A417 Missing Link

**Responding to feedback from
our public consultation 2019**

Purpose of document

Artists impression of green bridge proposed in autumn 2019

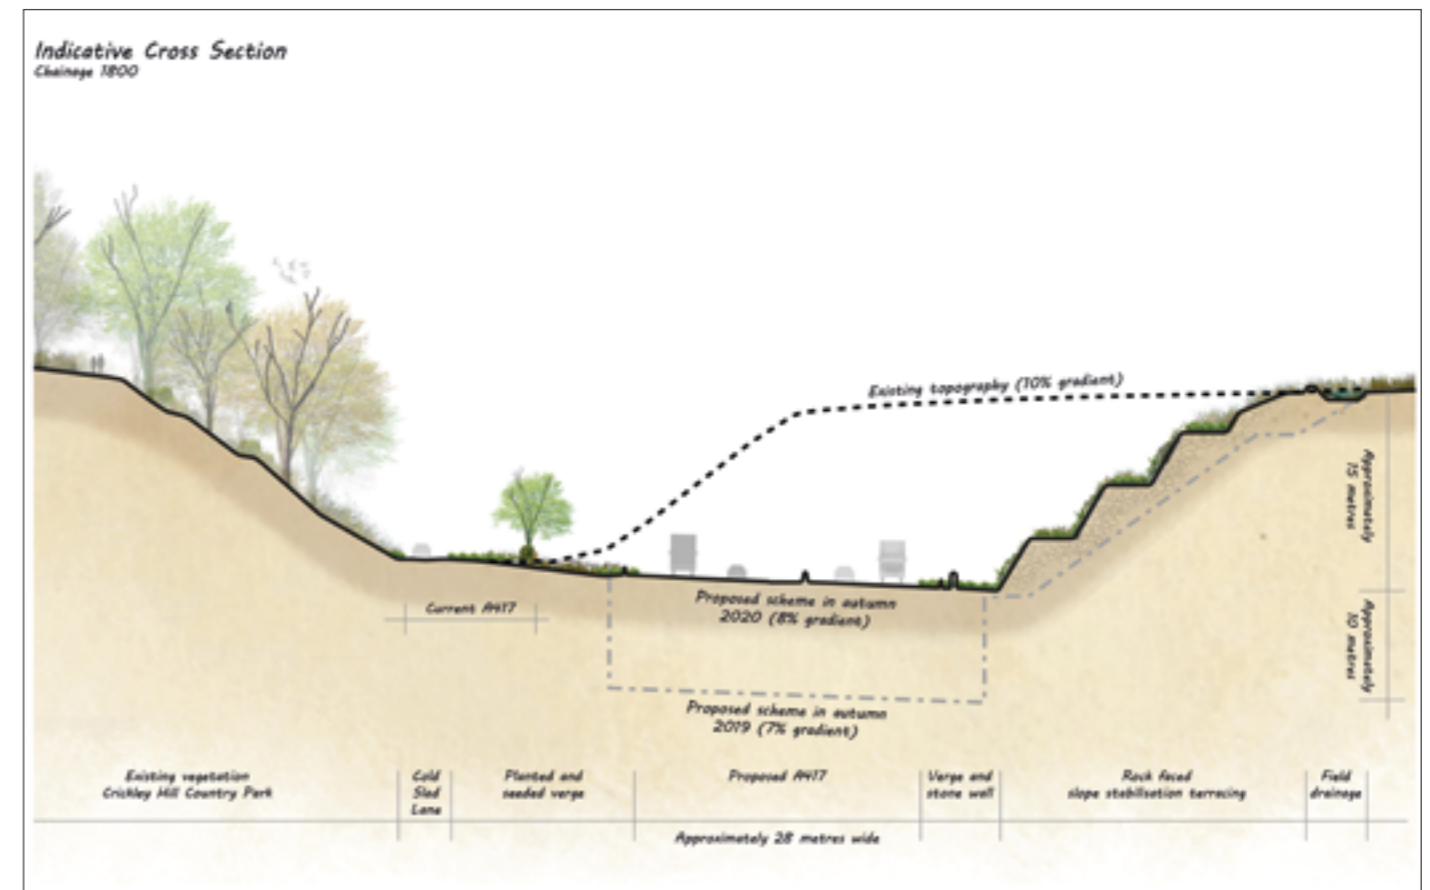
What you told us

Lots of people welcomed the idea of a green bridge but there were some concerns about its location and purpose. There were also concerns about its size and visual impact, and its effect on nearby veteran trees and a Site of Special Scientific Interest.

Our response

After careful consideration we've removed the structure from our plans. Its removal reduces the impact on Crickley Hill Country Park, Crickley Hill and Barrow Wake Site of Special Scientific Interest and nearby veteran trees.
